**Amendments to the Drawings:**

**Remarks/Arguments**

FIG. 4

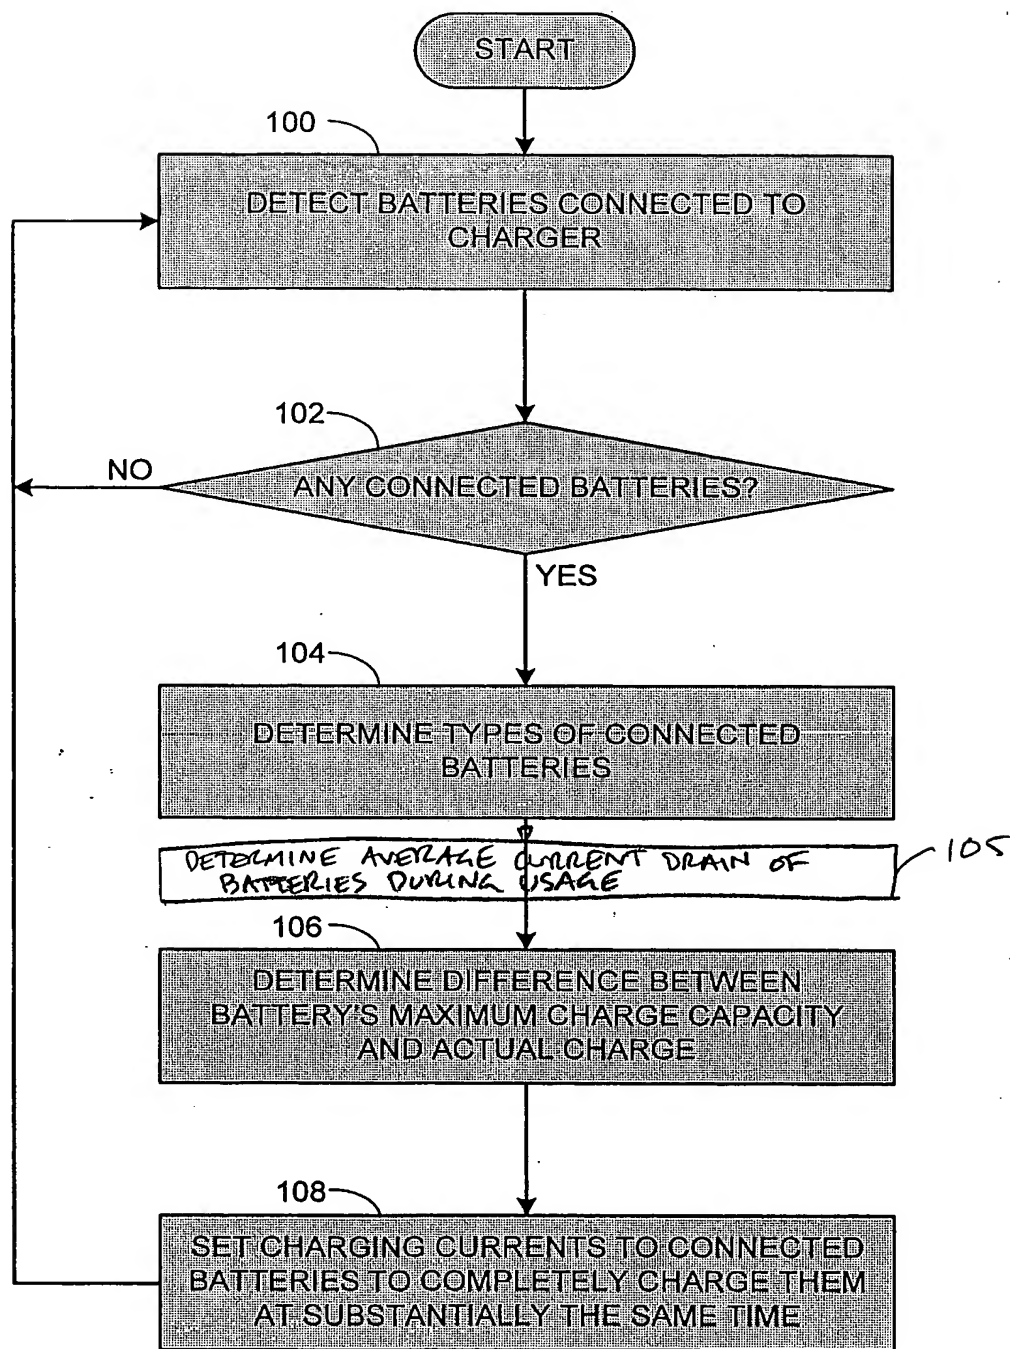
The attached sheet of drawings includes changes to Fig. 4. This sheet, which includes insertion of a new step designated by reference numeral 105, replaces the original sheet Fig. 4.

Figure 4 and the corresponding section of the description are amended to include a new step designated by reference numeral 105. Step 105 shows determining the average current drain of the batteries during usage, as requested by the Examiner.
